orbit_demo review notes: issues, trade-offs, questions, discrepancy register

Package section 09_review_notes of orbit_demo_design_review, written 2026-10-06. Links are relative to this file. Paths in backticks without a link (reports/..., build/..., site/..., viz/..., docs/research/..., ORFS image paths) are repository, build or tool-image paths in /home/user/chip that are not copied into the package. "repo" = /home/user/chip.

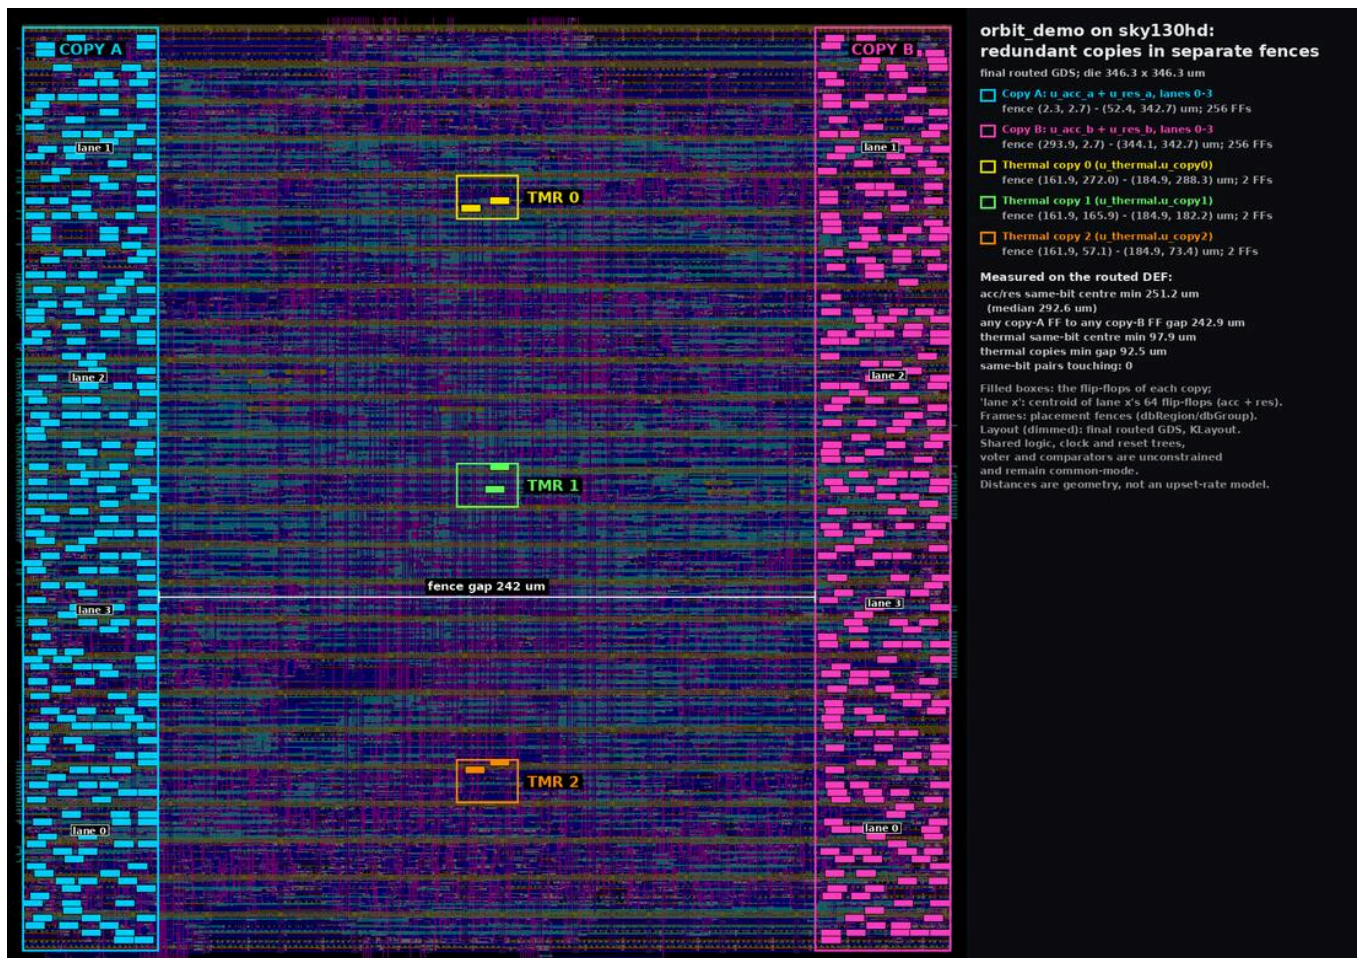
ID	Sev.	Description	Files	Evidence	Suggested resolution
D-13	Low	Fence gaps rounded inconsistently: regions.tcl "about 240 um" (copies) and "about 100 um" (thermal); summary.md "242 um"; PNG label "fence gap 242 um". Both "242 um" figures are the 241.50 um copy-A/B fence edge gap printed with 0 decimals (pdsep_summary.py 137, 445; pdsep_render.py 150-151), not the 242.94 um FF-to-FF gap (which would print as 243). Measured fence edge gaps 241.50 um (A/B), 89.76 and 92.48 um (thermal).	src/pd/sky130h_d_sep/regions.tcl; published_reports/summary.md, .png; src/scripts/pdsep_summary.py, pdsep_render.py	regions.tcl 49-50; summary.md 151, 153; separation.md 31, 53-62; pdsep_regions.txt 3-4	Quote measured values with their definition.
D-14	Low	regions.tcl/config.mk say the detailed placer keeps non-members from lying fully inside a fence; the routed DEF has 2 antenna diodes fully inside (inserted after placement). summary.md documents it.	regions.tcl; config.mk	regions.tcl 14-16; config.mk 48-53; separation.md 39; summary.md 121	Add "except antenna-repair diodes".
